Executive Order G-70-37-A

Relating to the Modification of the  
Certification of the Chevron Balance Phase II  
Vapor Recovery System for Service Stations

**EXHIBIT 1**  
**Executive Order 6-70-37-A**  
 Chevron Balance Phase II  
 Vapor Recovery System  
 Manifolded Vapor Return Lines

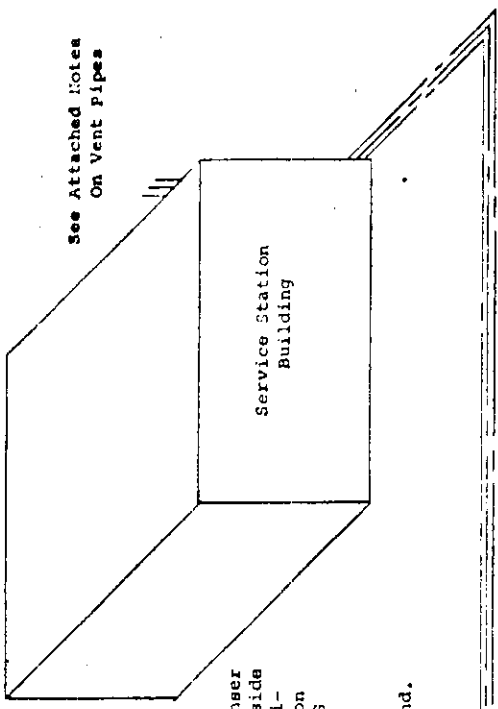
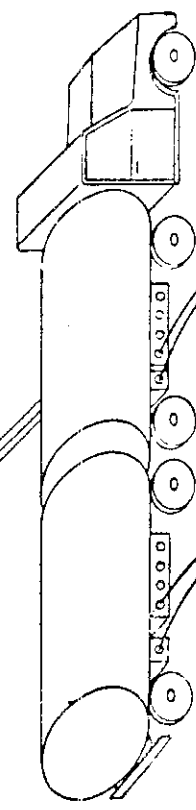
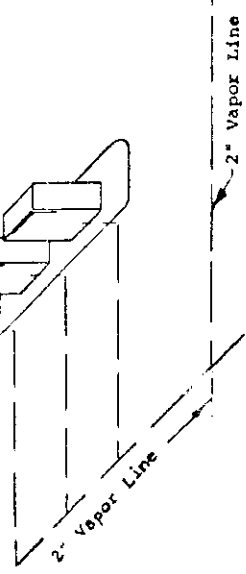
3/4" Galvanized Riser pipe stubbed either inside dispenser or on pump island. When inside dispenser install 0% 78 Anti-Recirculation Valve. When on island install 0% 78 or 78-S Anti-Recirculation Valve. Valve inlets to be 3 1/2" max. above top of island either inside dispenser or on island.

EXHIBIT 2  
Executive Order G-70-37-A  
Chevron Balance Phase II

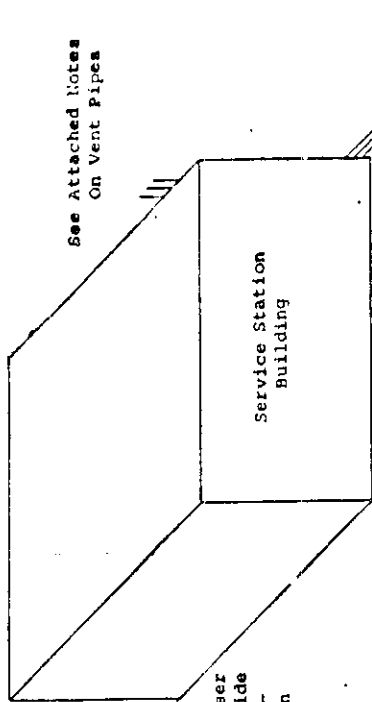
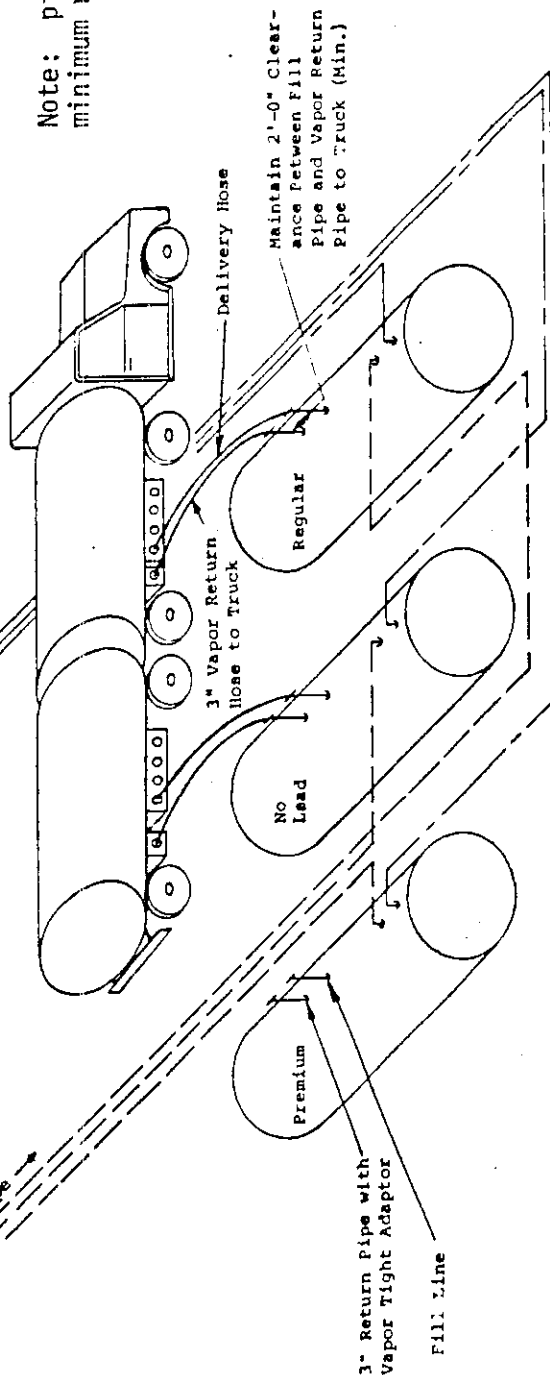
Note:  
3/4" Galvanized Riser Pipe  
stubbed either inside dispenser  
or on pump island. When inside  
dispenser install 0% 78 Anti-  
Recirculation Valve. When on  
island install 0% 78 or 78-S  
Anti-Recirculation Valve.  
Valve inlets to be 3 1/4" max.  
above top of island either  
inside dispenser or on island.
